City of Surrey PLANNING & DEVELOPMENT REPORT File: 7910-0316-00

Planning Report Date: July 11, 2011

PROPOSAL:

in order to permit the development of a 71-unit, 4storey apartment building and an 80-unit townhouse development.

CPTED REQUIREMENTS FOR UNDERGROUND PARKING

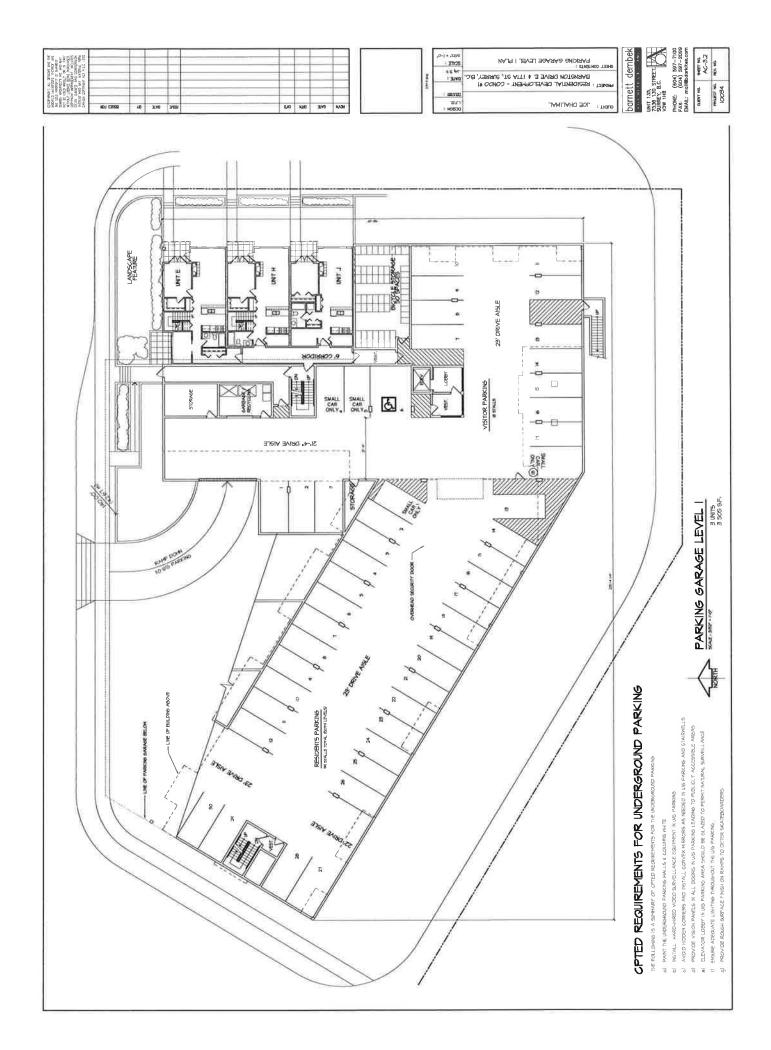
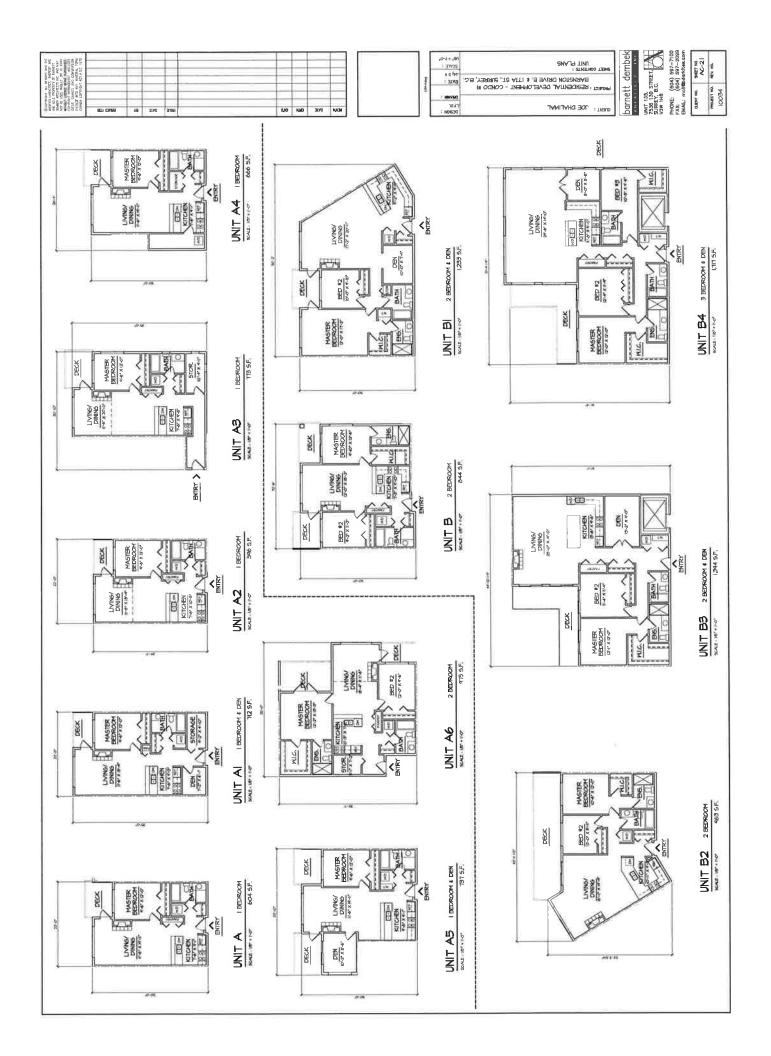
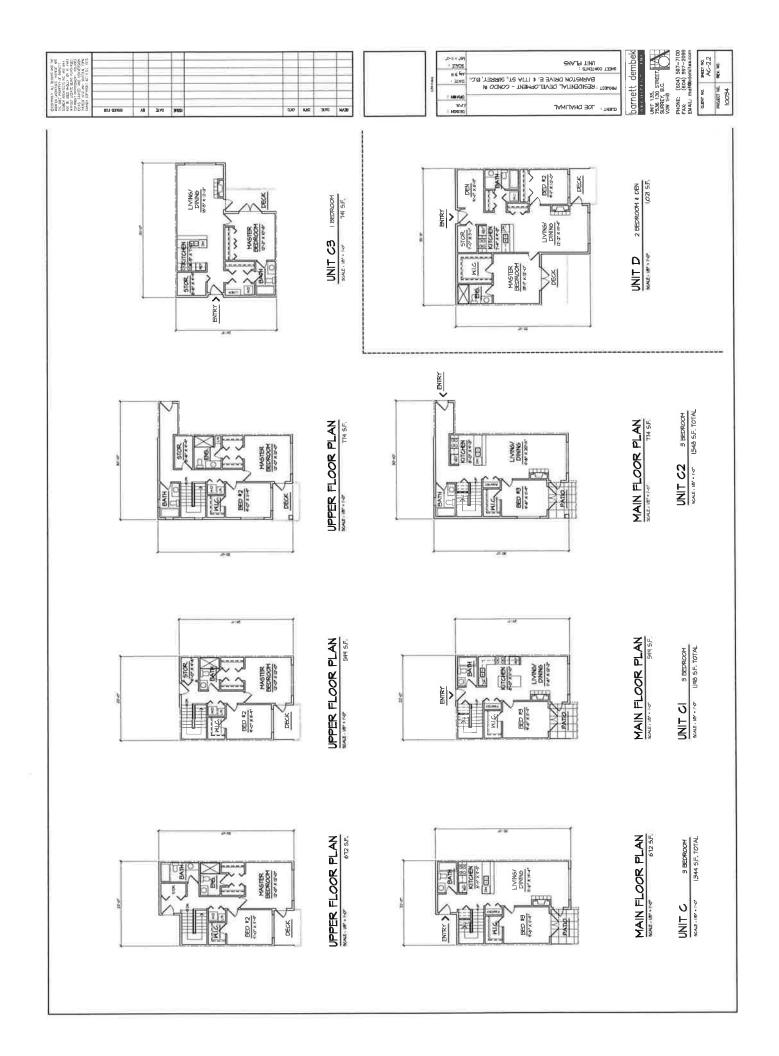
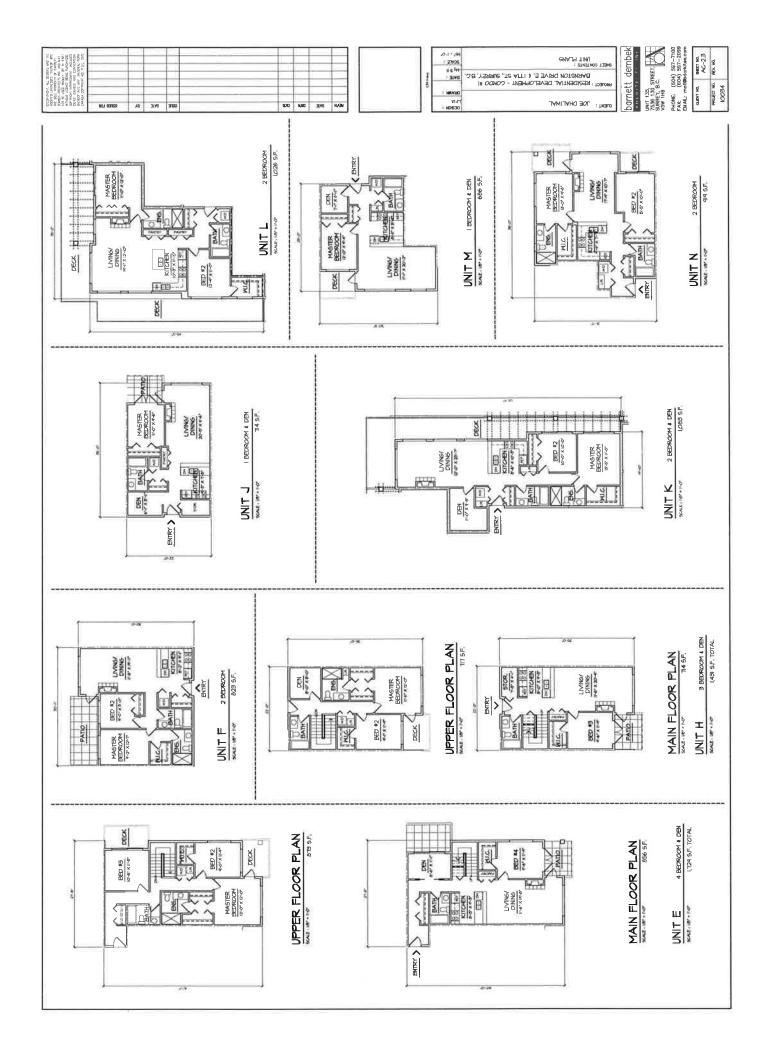
Underground parking – incorporate City's CPTED design guidelines at underground parking area.

(CPTED notes have been added to the underground parking level drawings.)
